DENCO CONSTRUCTION SPECIALISTS SHOP DRAWING AND SUBMITTAL REVIEW

Project Dallas Park & Rec Dept Admin Offices Location 10031 E. Northwest Highway Dallas, TX 75238

Items Submitted Carport

COVERED PARKING STRUCTURE SUPPORT FRAME SECTION
 @ 10031 E.Northwest Hwy., Dallas, TX
 For DENCO CS, Inc., Garland, TX
 Date: 2/27/17
 Drw'g. No.: SK-1

TYPICAL CARPORT WIND
 FRAME SECTION
 (MAX.SP'CG.BTWN.FRAMES=18'-0")

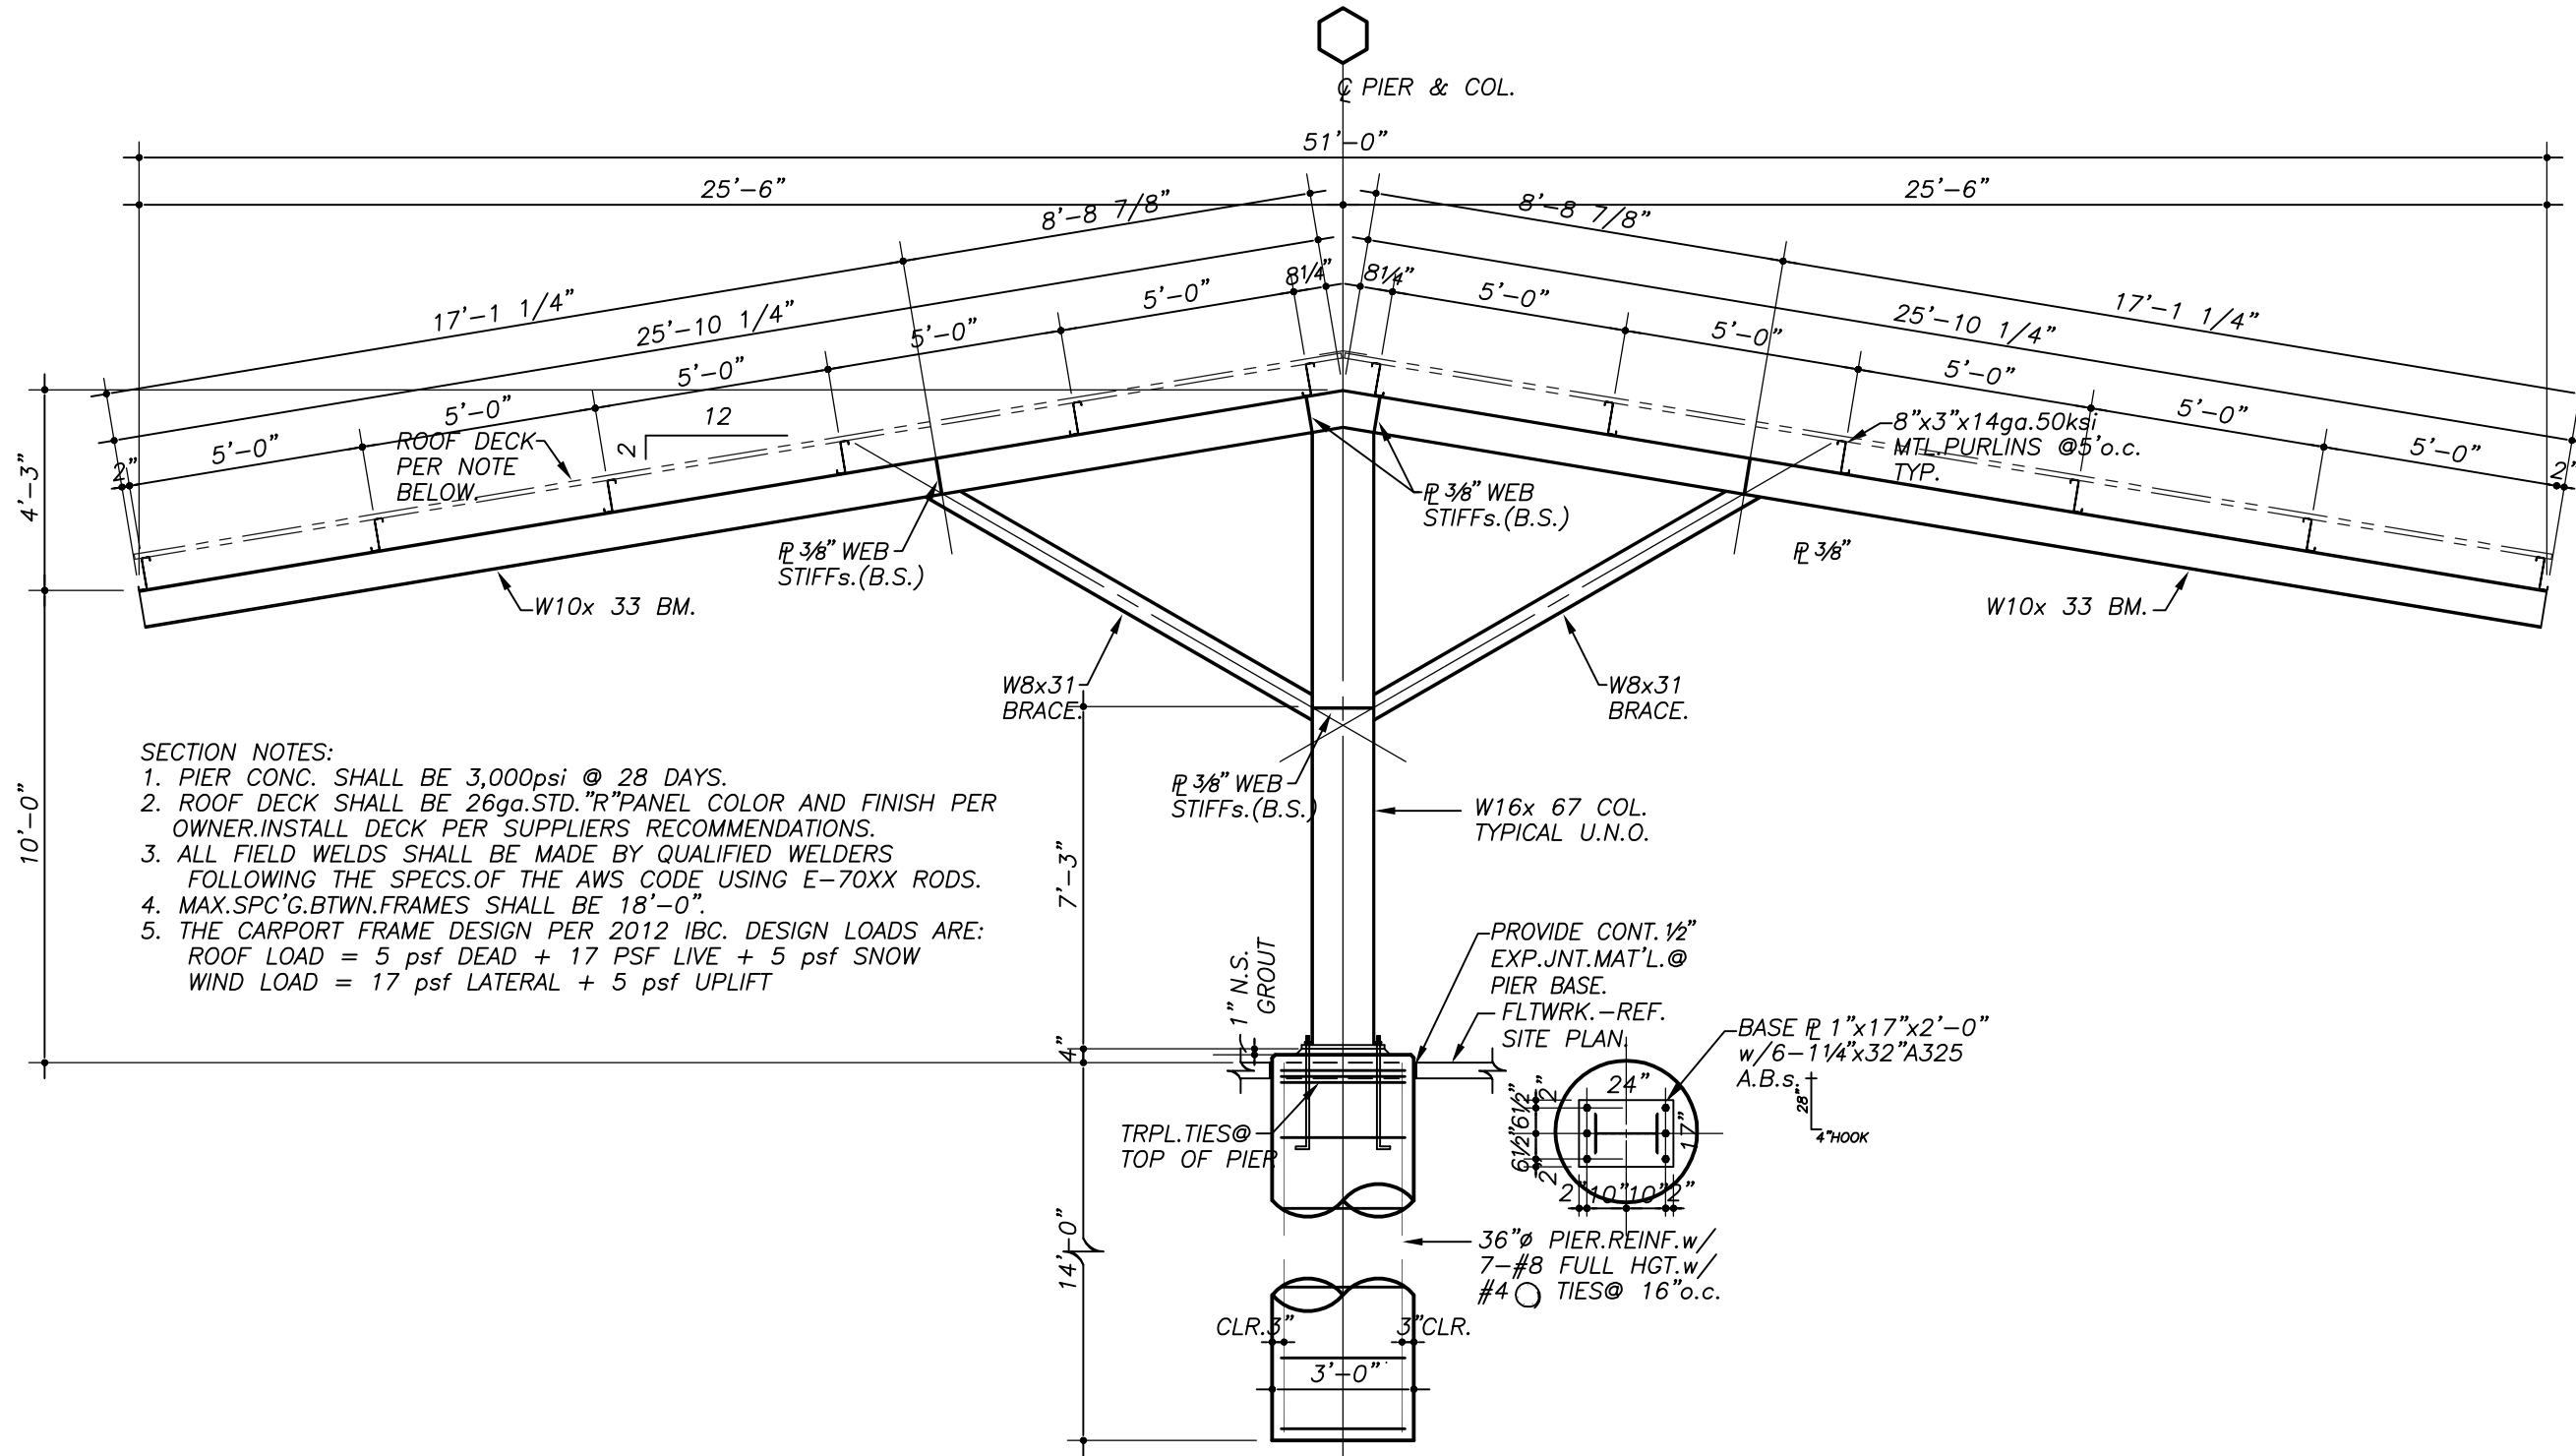
C - Revise And Resubmit	
SUBMITTAL REVIEW	
PERKINS	See Submittal Transmittal for important qualifications and limitations.
+ WILL	
Project No.:	<u>146054.000</u>
Submittal ID.:	<u>10 73 23-001</u>
Reviewed By:	<u>Tori Wickard</u>
Date:	<u>6/20/2018</u>

Submit the following items. They may be submitted separately but shop drawings need all to convey all information listed in specs:

1.3 ACTION SUBMITTALS

A. Product Data: For each type of product:

1. Include styles, material descriptions, construction details, fabrication details, dimensions of individual components and profiles, hardware, fittings, mounting accessories, features, and finishes for shelters.
2. Include rated capacities and furnished specialties and accessories.

B. Shop Drawings:

1. Include plans, elevations, sections, mounting heights, and details for attachment to other work.
2. Anchor-Bolt Plans: Submit anchor-bolt plans and templates. Include location, diameter, and projection of anchor bolts required to attach shelters to concrete bases. Indicate post reactions at each location

C. Samples for Initial Selection: For each type of exposed finish.

D. Samples for Verification: For the following:

1. Shade Fabric: 12-inch- (300-mm-) square section of fabric from dye lot to be used for the Work, with specified treatments applied. Mark face of fabric.
2. Frame Finish: Not less than 6-inch (150-mm) lengths.

1.4 INFORMATIONAL SUBMITTALS

A. Delegated-Design Submittal: For cantilevered car shelters.

B. Sample Warranty: For manufacturer's special warranty.
